AGENDA

May 18, 2017 Standards Committee Meeting

<u>Item No. 1</u>	<u>(2016 SS)</u>	<u>Ms. Phillips</u>	<u>pg 4</u>
601-TBGC-01		THRIE-BEAM GUARDRAIL COMPONENTS	
601-TBGC-02		THRIE-BEAM GUARDRAIL COMPONENTS	
601-MGSA-01		MIDWEST GUARDRAIL SYSTEM ASSEMBLY	
601-MGSA-02		MIDWEST GUARDRAIL SYSTEM ASSEMBLY	
601-MGSA-03		MIDWEST GUARDRAIL SYSTEM ASSEMBLY	
601-MGSA-04		MIDWEST GUARDRAIL SYSTEM ASSEMBLY	
601-MGSA-05		MIDWEST GUARDRAIL SYSTEM ASSEMBLY	
601-MGSA-06		MIDWEST GUARDRAIL SYSTEM ASSEMBLY, OMITTED POST	
601-MGSA-07		MIDWEST GUARDRAIL SYSTEM ASSEMBLY, OMITTED POST	
601-MGSA-08		MIDWEST GUARDRAIL SYSTEM ASSEMBLY, LONG-SPAN	
601-MGSA-09		MIDWEST GUARDRAIL SYSTEM ASSEMBLY, LONG-SPAN	
601-MGSA-10		MIDWEST GUARDRAIL SYSTEM ASSEMBLY, STRUCTURE TOP-MOUNTED POST	
601-MGSA-11		MIDWEST GUARDRAIL SYSTEM ASSEMBLY, GUARDRAIL TRANSITION WITH CURB	
601-MGSA-12		MIDWEST GUARDRAIL SYSTEM ASSEMBLY, GUARDRAIL TRANSITION WITHOUT CURB	
601-MGSA-13		MIDWEST GUARDRAIL SYSTEM ASSEMBLY, GUARDRAIL TRANSITION

PROPOSED SOLUTION: Replace the current strong post w-beam guardrail with non-proprietary Midwest Guardrail System (MGS) w-beam guardrail.

601-TBGC-02 THRIE-BEAM GUARDRAIL COMPONENTS (WITH MARKUPS)

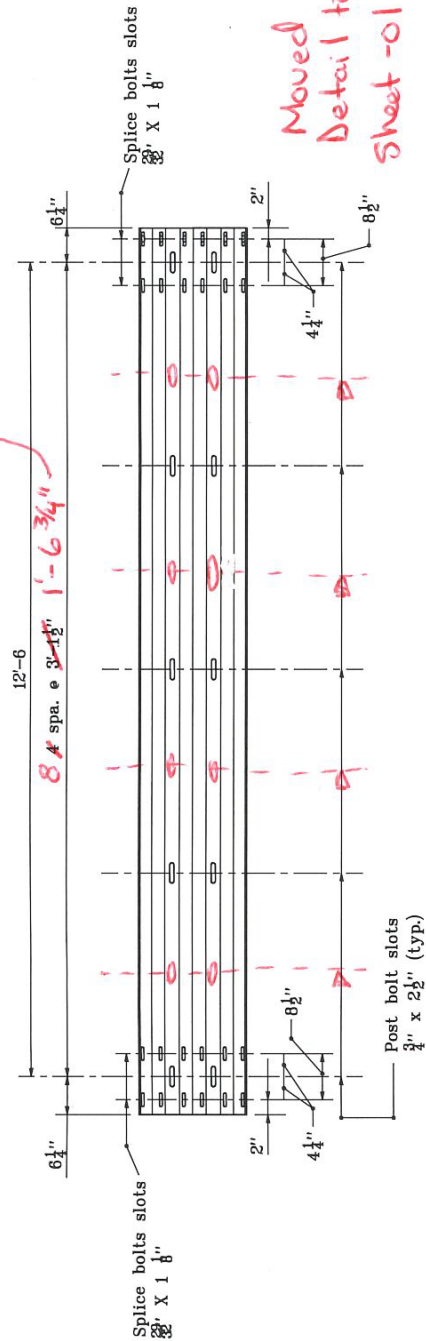
1. (Same Notes on -01)
MGS
→ Add extra holes for Guardrail Transition

Moved
Detail to
Sheet -01

Added Symmetric W-Beam to Thrie Beam Transition Section from Sheet -01

Add New Asymmetric W-Beam to Thrie Beam Transition Section

601-TBGC-02 THRIE BEAM TRANSITION SECTION (DRAFT)

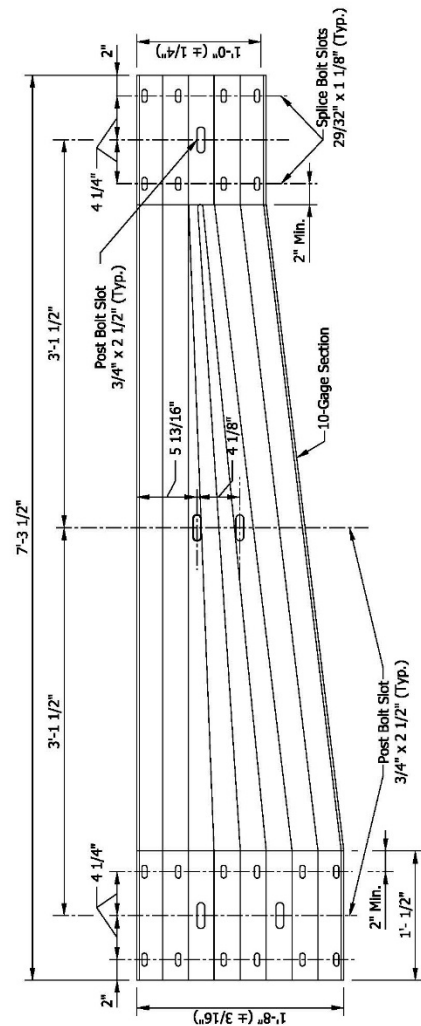
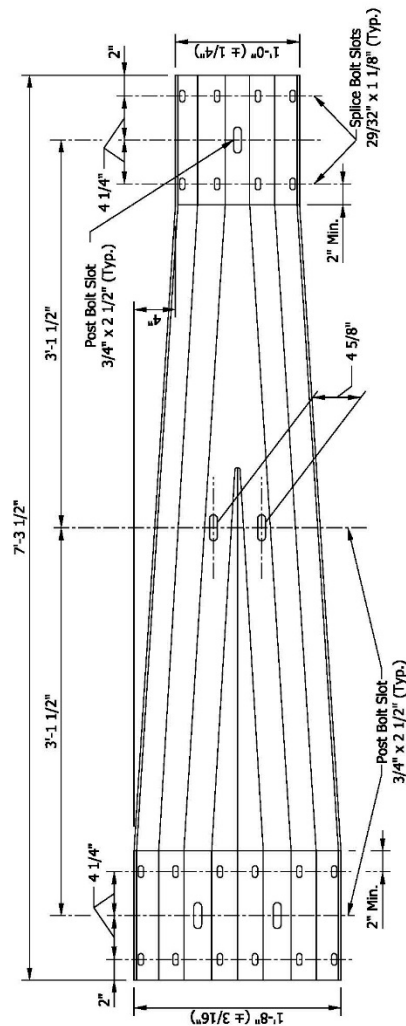
ASYMMETRIC MGS W-BEAM TO THRIE-BEAM TRANSITION SECTION

SYMMETRIC W-BEAM TO THRIE-BEAM TRANSITION SECTION
